# Access Compliance Report

## Public Rights-of-Way

### (Pedestrian Signals)

Intersection ID: N/A	Main Street:	Cross Street: N/A	Location: N/A
ADA ID: 80B4B8756AC3	Signal Type: One Push Button-Non APS	Overall Compliance: No	Severity Score: BTN 1: N/A BTN 2: N/A No BTN: N/A
Codes/Mitigation Info/Possible Solution		Field Measurements/Component Compliance

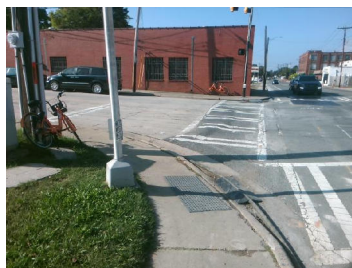
PROW/ADA: R404.2, R406.2, R404.7.3

Compliance	Description	Data	Compliance	Description	Data
	Button Count	Button1	N/A	Distant to Additional Button (in)	N/A
	Additional Button Present?	No		Additional Button ID	N/A
N/A	Signal Buttons Required?	N/A	N/A	Additional Ped Posts Required	N/A
	How Many Ped Street Xings?	2		Located In An Island/Median?	No
N/A	B 1 Sign Present?	Yes	N/A	B 2 Sign Present?	N/A
Yes	B 1 Sign Purpose?	Yes	N/A	B 2 Sign Purpose?	N/A
Yes	B 1 Sign Lettering & Contrast?	Yes	N/A	B 2 Sign Lettering & Contrast?	N/A
Yes	B 1 Parallel To XWalk?	Yes	N/A	B 2 Parallel To XWalk?	N/A
Yes	B 1 PAR to Button?	Yes	N/A	B 2 PAR to Button?	N/A
Yes	B 1 PAR to XWalk?	Yes	N/A	B 2 PAR to XWalk?	N/A
Yes	B 1 Clear Floor Space?	Yes	N/A	B 2 Clear Floor Space?	N/A
N/A	B 1 FWD Approach?	Yes	N/A	B 2 FWD Approach?	N/A
N/A	B 1 FWD Approach Constrained?	No	N/A	B 2 FWD Approach Constrained?	N/A
No	B 1 FWD Approach Reach (in)	12.0	N/A	B 2 FWD Approach Reach (in)	N/A

N/A	B 1 FWD Approach Width (in)	N/A	N/A	B 2 FWD Approach Width (in)	N/A
N/A	B 1 FWD Approach Obstruction?	Yes	N/A	B 2 FWD Approach Obstruction?	N/A
N/A	B 1 FWD Approach Obstruction Dist (in)	5.0	N/A	B 2 FWD Approach ObstructionDist (in)	N/A
N/A	B 1 PARA Approach?	Yes	N/A	B 2 PARA Approach?	N/A
N/A	B 1 PARA Approach Constrained?	No	N/A	B 2 PARA Approach Constrained?	N/A
No	B 1 PARA Approach Reach (in)	12.0	N/A	B 2 PARA Approach Reach (in)	N/A
N/A	B 1 PARA Approach Width (in)	N/A	N/A	B 2 PARA Approach Width (in)	N/A
N/A	B 1 PARA Approach Obstruction?	Yes	N/A	B 2 PARA Approach Obstruction?	N/A
N/A	B 1 PARA Approach Obstruction Dist (in)	5.0	N/A	B 2 PARA Approach ObstructionDist (in)	N/A
Yes	B 1 Clear Floor Space Slope (%)	2.7	N/A	B 2 Clear Floor Space Slope (%)	N/A
No	B 1 Clear Floor Space XSlope (%)	12.3	N/A	B 2 Clear Floor Space XSlope (%)	N/A
N/A	B 1 PAR Slope (%)	6.8	N/A	B 2 PAR Slope (%)	N/A
Yes	B 1 Height (in)	41.5	N/A	B 2 Height (in)	N/A

Possible Solutions: Provide Push Button Extension. Remove and Replace Clear Space.
